**Marine Stewardship Council (MSC) Conformity Assessment Body
Response to Notice of Objection**

Usufuku Honten Northeast Atlantic longline bluefin tuna fishery

Control Union Pesca Ltd

February 2020

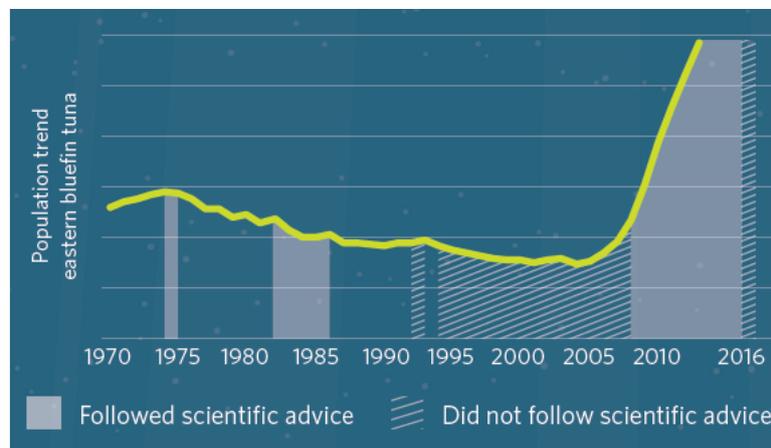
PEW provided an analysis of how ICCAT has responded to scientific advice for BFT-e from 1970-2016 (see Figure below taken from PEW (2017)). This shows that ICCAT have followed scientific advice on eastern bluefin every year from 2008-2015; the only exception the authors find since 2008 in their analysis is 2016.

If you look at the advice to the Commission from SCRS in 2016 (in the SCRS report 2016) it is the following (Section BFTE6 – Management Recommendations):

- The goal of achieving BMSY with at least 60% probability might already have been reached or will soon be reached. Therefore, the Commission should consider adding a new phase to the current recovery plan.
- Having considered the stock indicators, the Committee advises that catches not exceeding TACs in Rec. 14-04 are not expected to undermine the success of the rebuilding plan and are consistent with the goal of achieving FMSY and BMSY through 2022 with at least 60 % of probability.

Since the Commission did not change the TACs, which remained consistent with Rec 14-04 (Table 8) we can only suppose that by ‘did not follow scientific advice’ PEW meant that the Commission did not change the recovery plan in 2016. However, given that a stock assessment was due in 2017, and given that when the recovery plan was changed to a multi-annual management plan, the management measures were made slightly less strict as would be expected (see comparison in Table 9), to us the Commission decisions were i) logical and ii) more precautionary than the advice rather than the reverse.
